# Access Compliance Report

## Public Rights-of-Way (Curb Ramps)

Intersection ID: 3750	Main Street: DEER_CROSS_TL	Cross Street: HERITAGE_WOODS_PL	Location: SW
ADA ID: FE9A24F42A18	Ramp Type: Directional1	Initial Pass/Fail: Fail	Overall Compliance: No
			Severity Score: 21.25

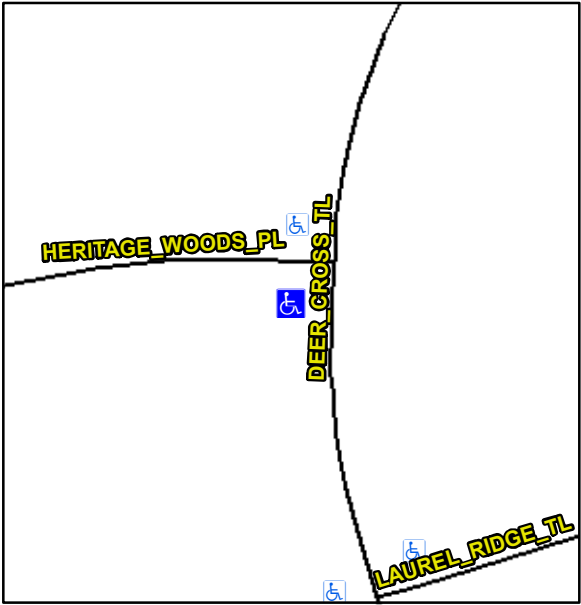
Codes/Mitigation Info/Possible Solution			Field Measurements/Component Compliance		
	Possible Solutions:		<b>Compliance</b>	<b>Description</b>	<b>Data</b>
	Remove & Replace Entire Ramp.		N/A	Ramp Length (in)	32.0
			No	Ramp Width (in)	40.0
			No	Ramp Slope (%)	9.7
			Yes	Ramp XSlope (%)	0.9
			N/A	Flare Type LT	N/A
			N/A	Flare Slope LT (%)	N/A
			N/A	Flare Traversable LT?	N/A
			N/A	Flare Type RT	N/A
			N/A	Flare Slope RT (%)	0.0
<p>Surveyor Notes:</p> <p>N/A</p>			N/A	Grade Break?	N/A
			N/A	Grade Break Slope (%)	0.0
			N/A	Grade Break XSlope (%)	0.0
			N/A	Flare Type RT	N/A
			N/A	Flare Slope RT (%)	0.0
			N/A	Flare Traversable RT?	N/A
			N/A	DWS Provided?	N/A
			N/A	DWS Contrast?	N/A
			N/A	DWS Length (in)	N/A
			N/A	DWS Full Width?	N/A
<p>PROW/ADA:</p> <p>R304.5.1, R304.2.2</p>			N/A	DWS Offset LT (in)	N/A
			N/A	DWS Offset RT (in)	N/A
			N/A	Gutter Slope (%)	N/A
			N/A	Gutter Lip Ht (in)	N/A
			N/A	Gutter X Slope (%)	N/A

N/A	Road Slope (%)	1.3
			N/A	Road X Slope (%)	4.0
			N/A	Clear Space?	N/A
			N/A	Clear Space to XWalk (in)	N/A
			N/A	Storm Grate/Utility Hazard?	N/A
<p>Total Cost:</p> <p>\$ 1600.00</p>			N/A	Storm Grate/Utility Type	N/A
			N/A	Obstruction Type	N/A
			Yes	Surface Condition? (G/P)	Good
			N/A	Curb Slope (%)	12.6
